THE COMMONWEALTH OF MASSACHUSETTS WATER RESOURCES COMMISSION

WATER RESOURCES COMMISSION FINDINGS

Compliance with the Environmental Criteria Of the Interbasin Transfer Act Aquaria Regional Desalinization Project

August 14, 2003

Figure 2. Hydrodynamic Model Calibration

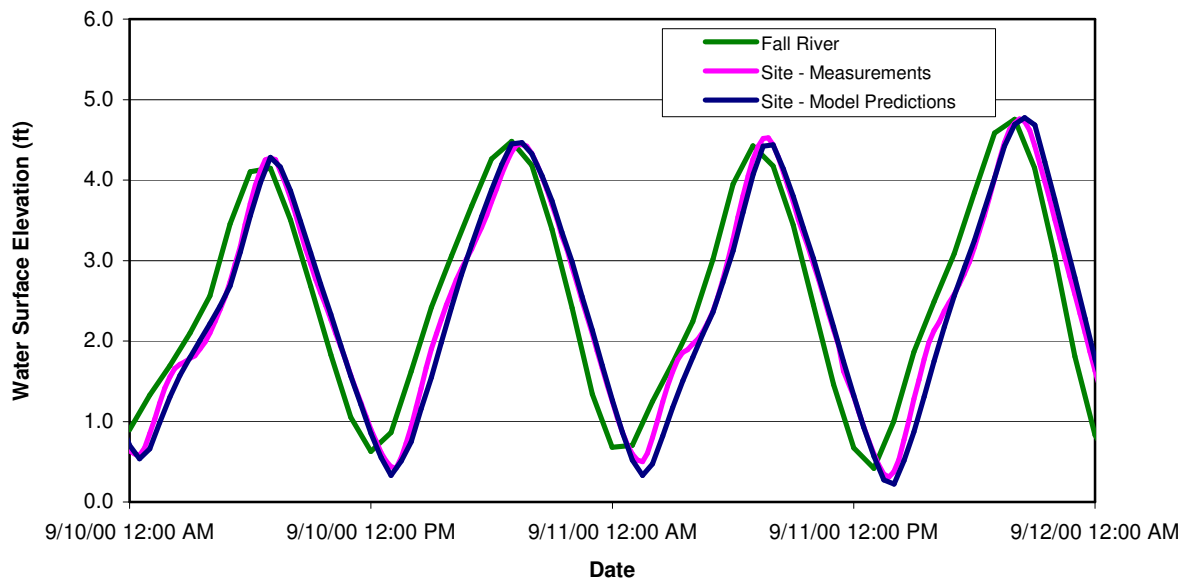
The proponent modeled water elevation from the site in Dighton to Fall River downstream. The figure below provides the results of the model calibration for water level elevation.

The measured elevations at the site for 9/10/00 to 9/12/00 match the modeled elevations. Figure 3 shows the elevations with and without the net 10 mgd operation. The water elevations for the two simulations cannot be distinguished on the graph indicating no change in elevation.

Figure 3. Tidal Water Levels at Proposed Plant Site

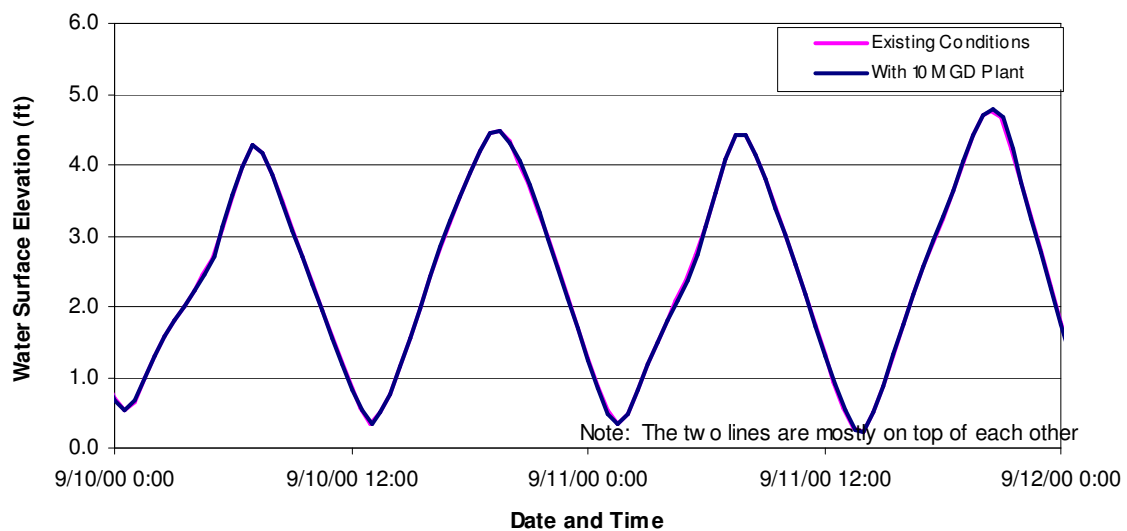
Due to the withdrawal of water during tidal rise and fall, no impact to water elevation will occur during flood, moderate or low flow periods from the proposed transfer.

Figure 8. Salinity Time Variations for 7Q10 Flow with 10 MGD Withdrawal

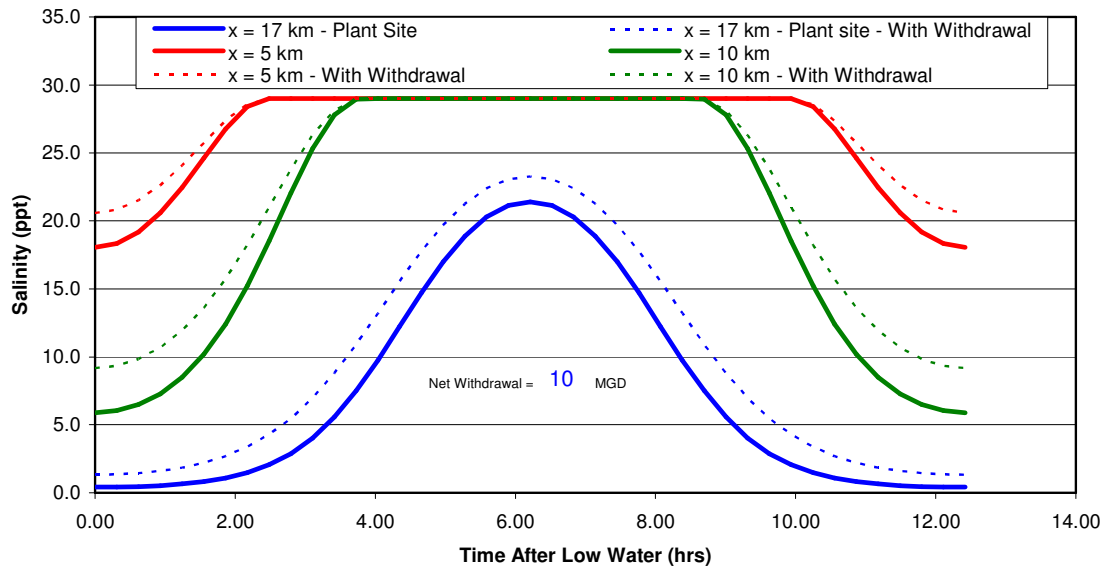
Salinity was simulated at the Braga Bridge in Fall River (11 miles downstream at the mouth of the Taunton River) and at the plant site in Dighton. In addition salinities are simulated for several locations in between these sites and upstream from the plant. Simulations were done for a net 10 mgd transfer during 7Q10 flow conditions (seven consecutive days of low flow which occurs with a frequency of every ten years). The graph below illustrates the change in salinity due to the withdrawal at the plant site and at two locations downstream from the plant. In addition the simulated salinity data for all the locations is included in Table 1.

Modeled salinity at the plant site varies from 0 to 23 ppt during the tidal cycle under 7Q10 flow conditions. The simulation shows an average increase in salinity of 2 ppt during these low river flow conditions. The variation is well within the natural variation at this site. Average changes in salinity upstream ranged from 0.3 to 1.4 ppt, which is also within the range of variation seen at these sites. Experts from Coastal Zone Management, Marine Fisheries and Natural Heritage felt these changes in salinity would not affect the existing flora and fauna.
